NOVEMBER 17, 2025

CONTRACT No. 1827

MISC. HVAC IMPROVEMENTS PROJECT

ADDENDUM No. 02

WEST ELEVATION

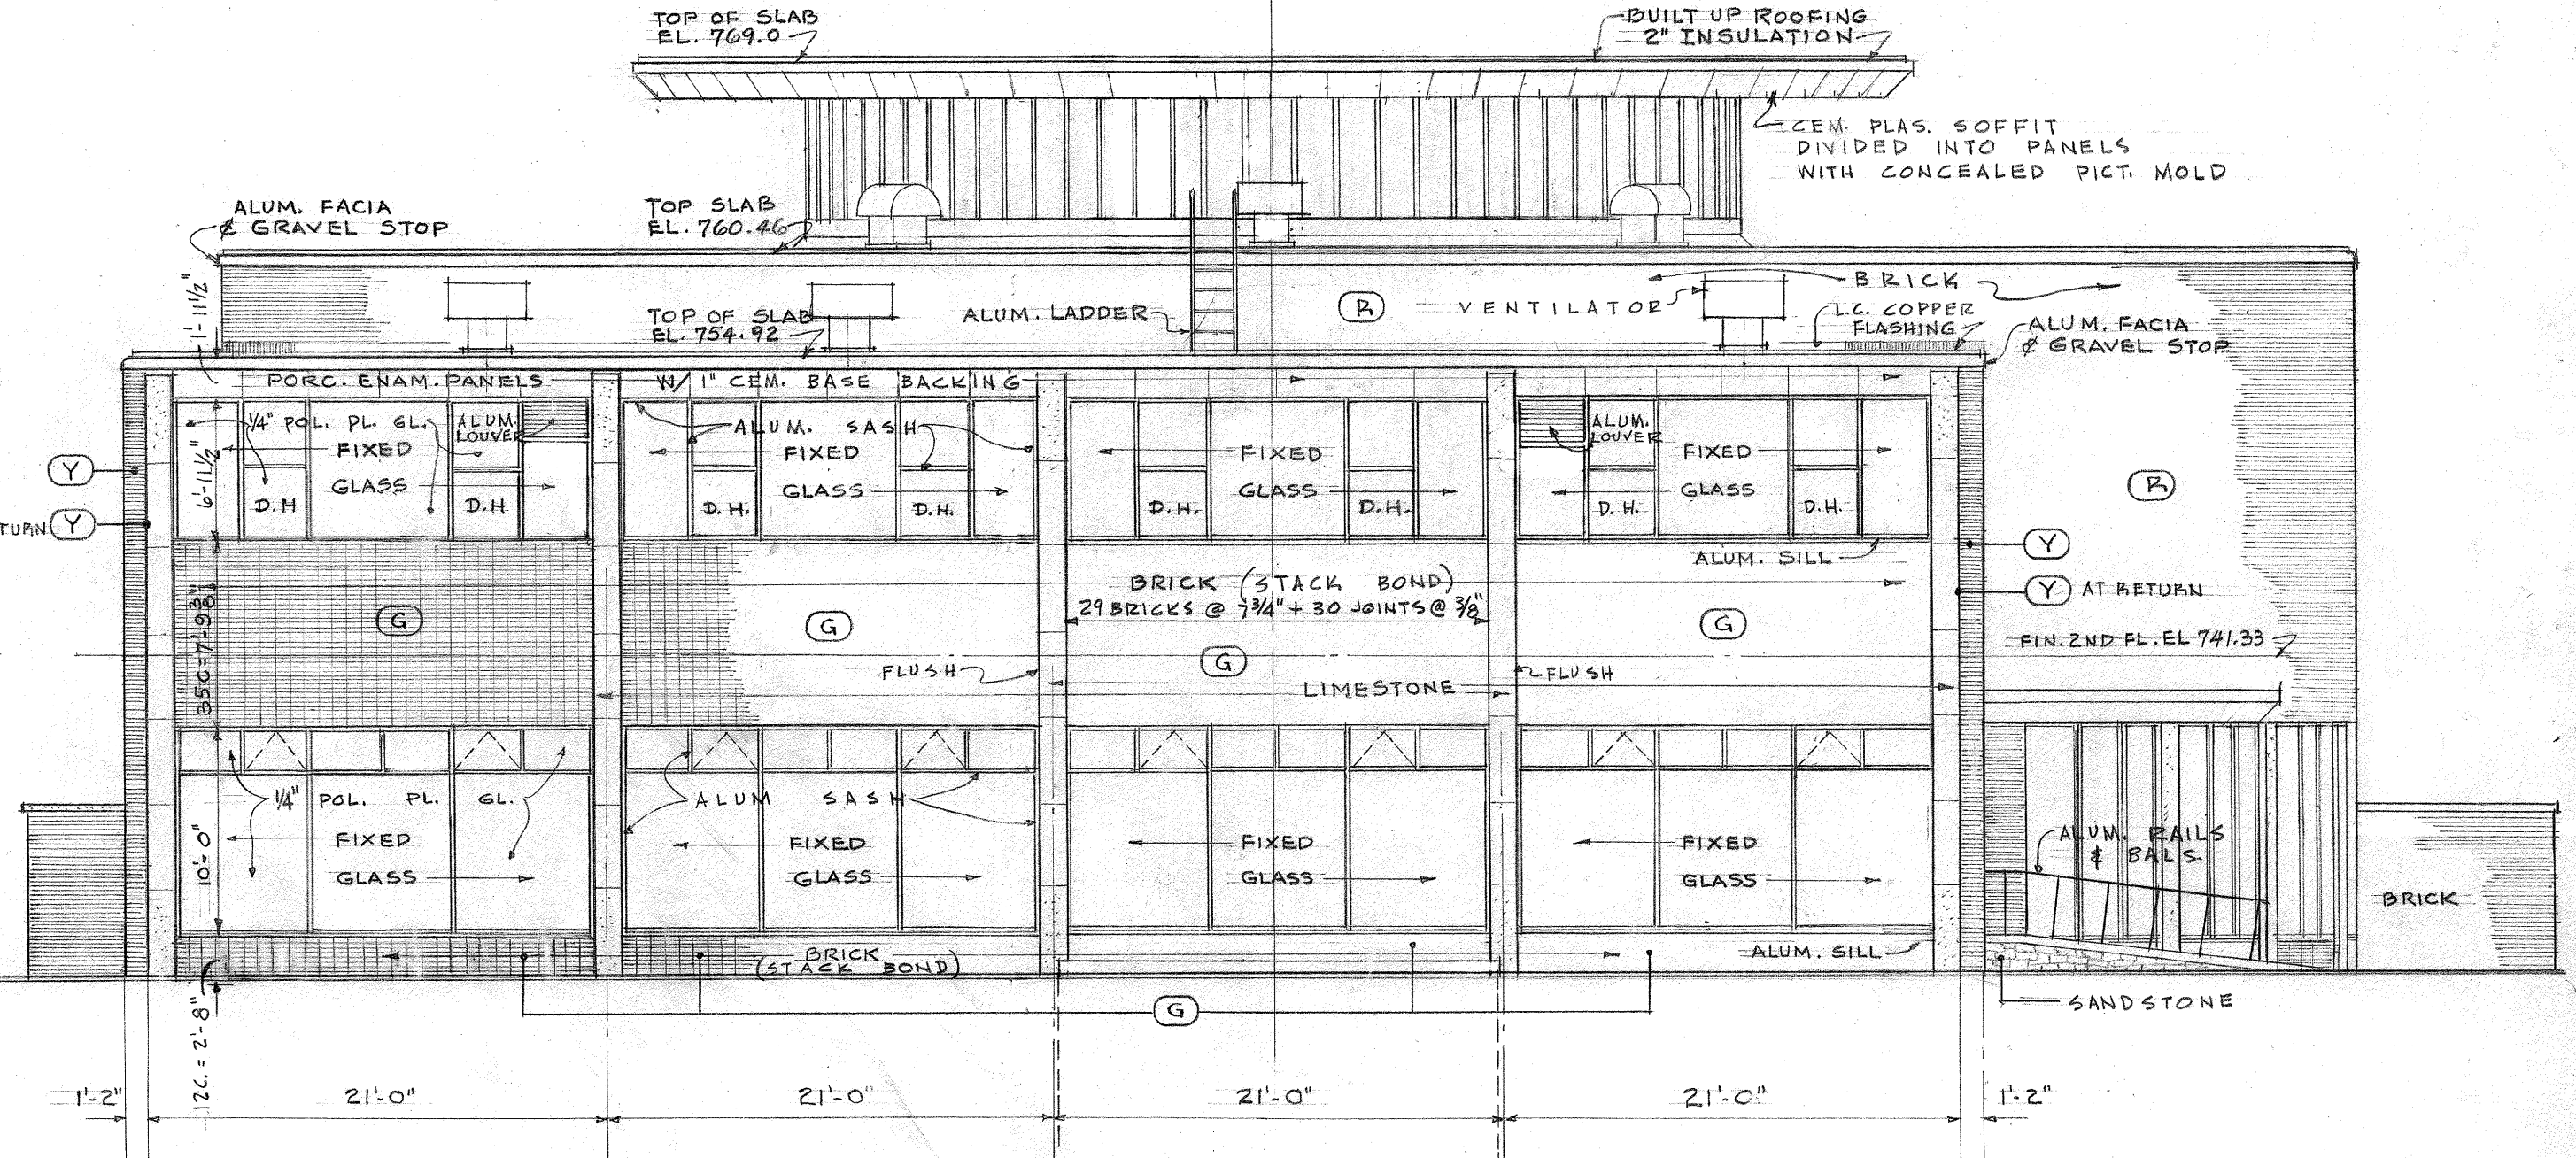
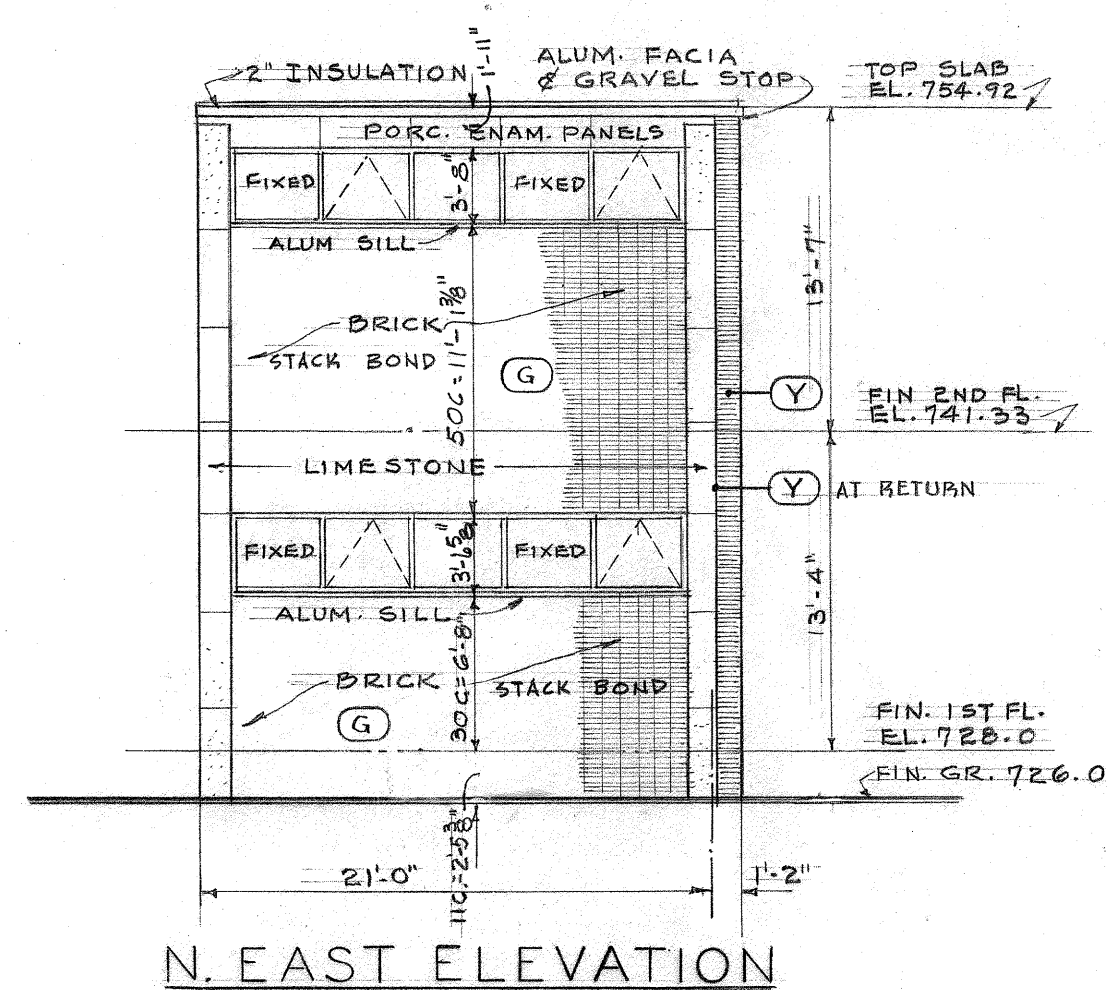
- 3.1 Additional asbestos surveying has been completed at the west headworks (512) and annex buildings (110). No asbestos was found. See attachment A and B.
- 3.2 Add sheet M-6, referencing pump station (500) elevation. See attachment C.

Q2: Can we get elevations for the buildings? Especially building 400 and 500

A2: Building 400 is approximately 60 feet, as shown on 400-A-01. Building 500 is approximately 26' 11" as shown on attached drawing M-6 being added to the reference folder. Building 110 is 2 stories and is approximately 30 feet. From Basement, elevation is 42 feet.

510-EDT-01
ELECTRICAL POWER FIRST FLOOR
DEMOLITION PLAN

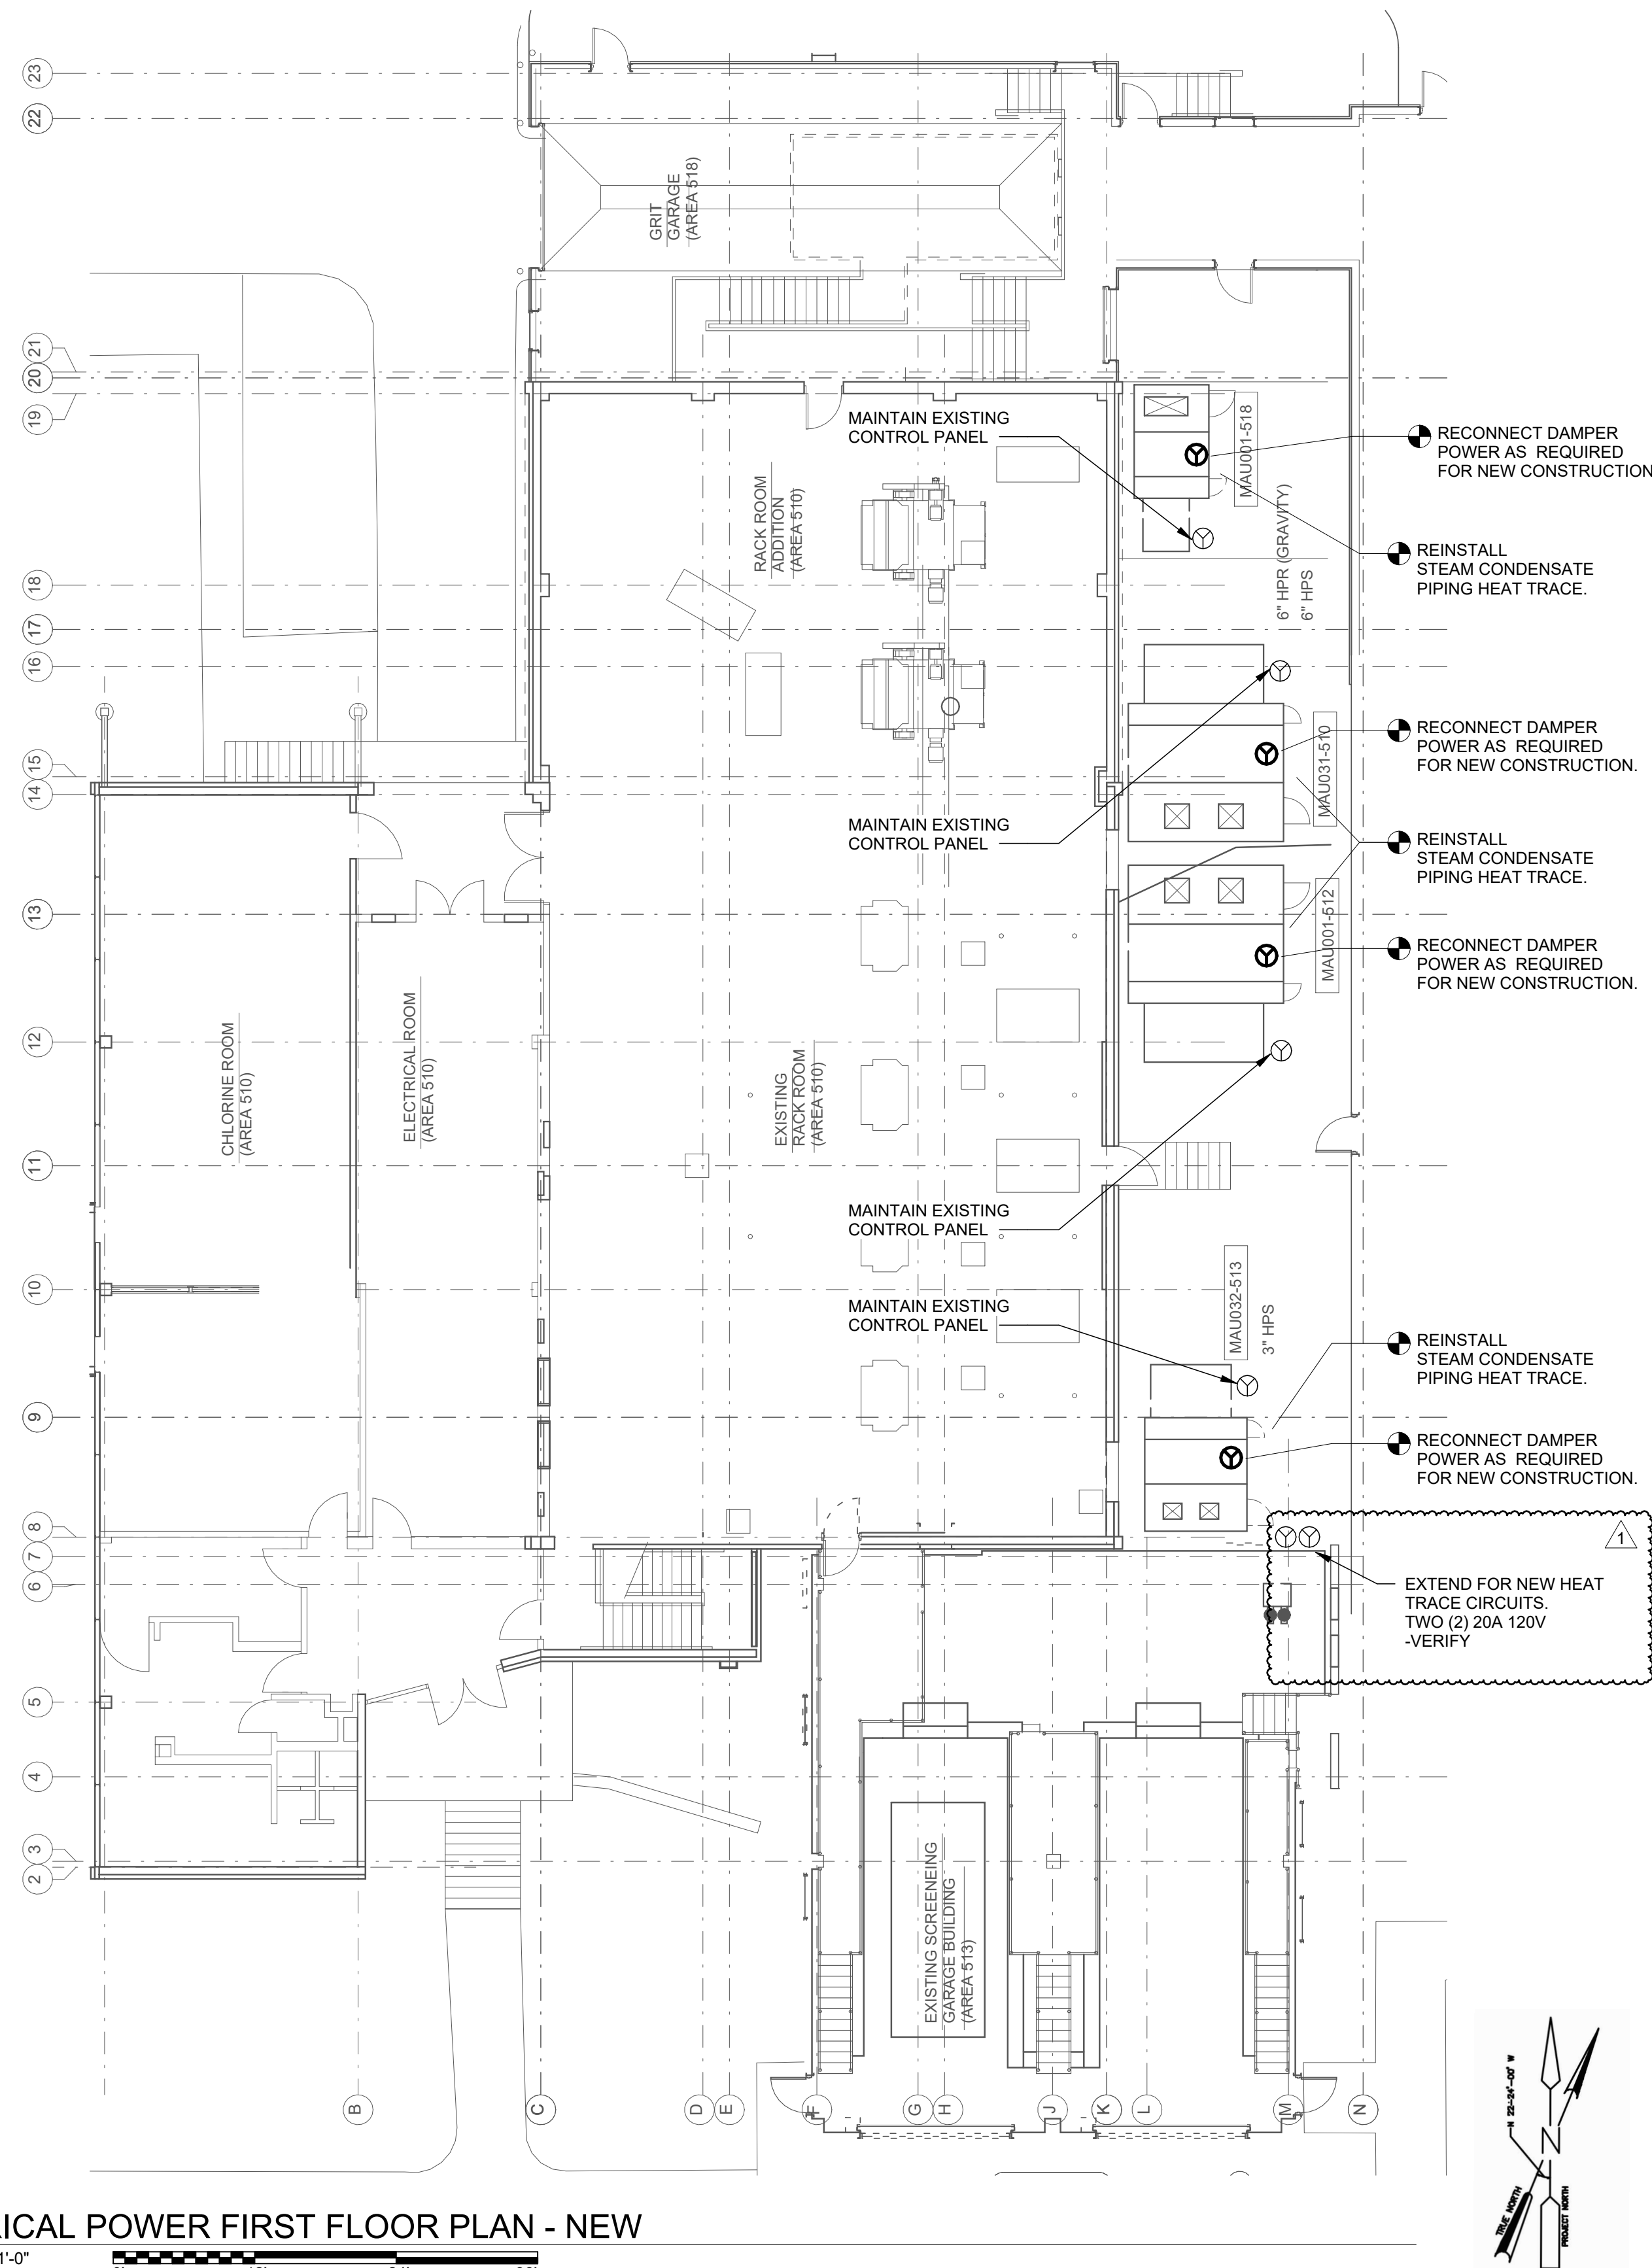
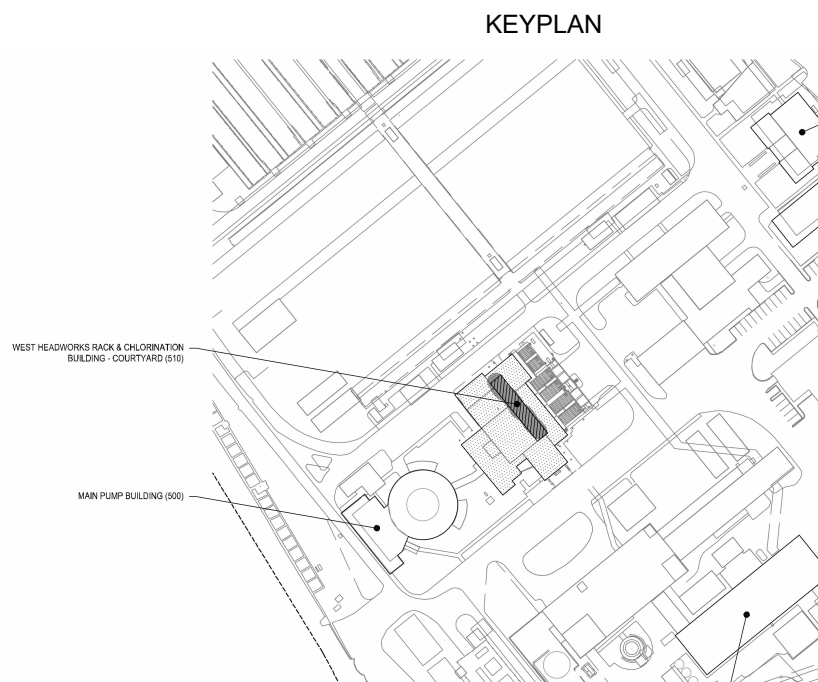
- 1.1 In Volume 2 of 3, Specification Section 01 11 00 SUMMMARY OF WORK Section 1.2 C add:
 - 11. Building 510, Disconnect existing heat trace circuits and prepare for connection to new replace in kind system.
- 1.2 In Volume 2 of 3, Specification Section 01 11 00 SUMMMARY OF WORK Section 1.2 D add:
 - 18. Building 510, Disconnect and remove heat trace system in its entirety. Replace in kind.
- 1.3 In Volume 2 of 3, Specification Section 23 09 00 INSTRUMENTATION AND CONTROL FOR HVAC, see Attachment E for revised sections 1.2 System Description, 1.11 Scope, 2.1 Controls System Architecture.

- 2.1 510-EDT-01-ELECTRICAL POWER FIRST FLOOR DEMOLITION PLAN
- 2.2 510-ET-01-ELECTRICAL POWER FIRST FLOOR NEW WORK PLAN
- 2.3 510-HDM-01-HVAC FIRST FLOOR DEMOLITION PLAN
- 2.4 510-HM-01-HVAC FIRST FLOOR NEW WORK PLAN
